UNITED STATES PATENT AND TRADEMARK OFFICE

APPLICATION NO.	FILING DATE	FIRST NAMED INVENTOR	ATTORNEY DOCKET NO.	CONFIRMATION NO.
10/057,067	01/25/2002	Charles R. Sperry	D-30259-01	3363
7590 12/14/2004			EXAMINER	
Sealed Air Corporation (US) P.O. Box 464 Duncan, SC 29334			SIMONE, CATHERINE A	
			ART UNIT	PAPER NUMBER
			1772

Office Action Summary

DETAILED ACTION

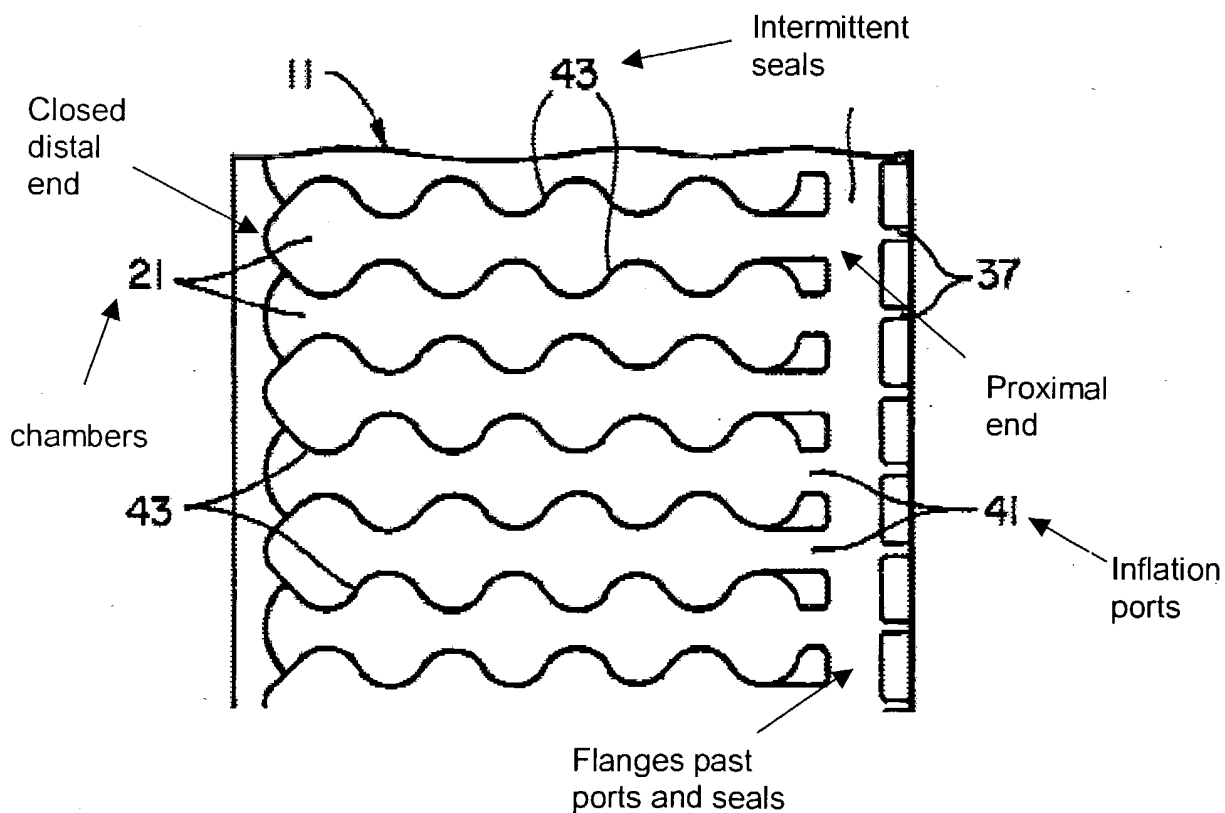
De Luca et al. discloses an inflatable web comprising two sheets (see col. 2, lines 47-51) having inner surfaces sealed to each other in a pattern defining a series of inflatable chambers (Fig. 2, #21) of predetermined length, each of the chambers (Fig. 2, #21) having at least one change in width over their length; an inflation port (Fig. 2, #41) located at a proximal end of each chamber, the inflation ports being formed by intermittent seals (Fig. 2, #43) between the sheets; and longitudinal flanges (see Figure shown below) formed by a portion of each of the sheets that extend beyond the inflation ports and intermittent seals. However, De Luca et al. fails to disclose the flanges having a pair of open, unsealed edges. Jostler et al. teaches that it is old and well-known in the analogous art to have longitudinal flanges having a pair of open, unsealed edges (Fig. 1a, #24a,b; also see col. 2, lines 39-45) for the purpose of filling the pockets (chambers) with some material in order to inflate them. Therefore, it would have been obvious to one of ordinary skill in the art at the time the applicant's invention was made to have modified the longitudinal flanges in De Luca et al. to have a pair of open, unsealed edges as suggested by Jostler et al. in order to inflate the chambers to produce a packaging material.

Regarding **claim 2**, note in De Luca et al. the chambers (Fig. 1, #23) comprise at least two inflatable sections of relatively large width connected by relatively narrow inflatable passageways (Fig. 1, #25). Regarding **claim 3**, note in De Luca et al. the inflation ports (Fig. 1, #41) are narrower in width than the inflatable sections of relatively large width (Fig. 1, #21). Regarding **claim 4**, note in De Luca et al. each of the sheets comprises a heat-sealable thermoplastic polymer on its inner surface (see col. 7, lines 3-5). Regarding **claim 5**, note in De Luca et al. the sections of relatively large width are circular (Fig. 1, #21) and capable of forming essentially spherical or hemispherical bubbles when inflated. Regarding **claim 6**, note in De

Luca et al. the pattern defining the inflatable chambers form uninflatable planar regions (Fig. 1, #43) between the inflatable chambers (Fig. 1, #21). Regarding **claim 7**, note in De Luca et al. the flanges inherently have a width of at least $\frac{1}{4}$ inch (see Figure shown below). Regarding **claim 8**, the flanges in De Luca et al. are substantially equal in width (see Figure shown below).

Regarding **claim 9**, note in De Luca et al. each of the inflatable chambers (Fig. 1, #21) has a closed distal end opposite from the proximal end of each chamber (see Figure shown below).
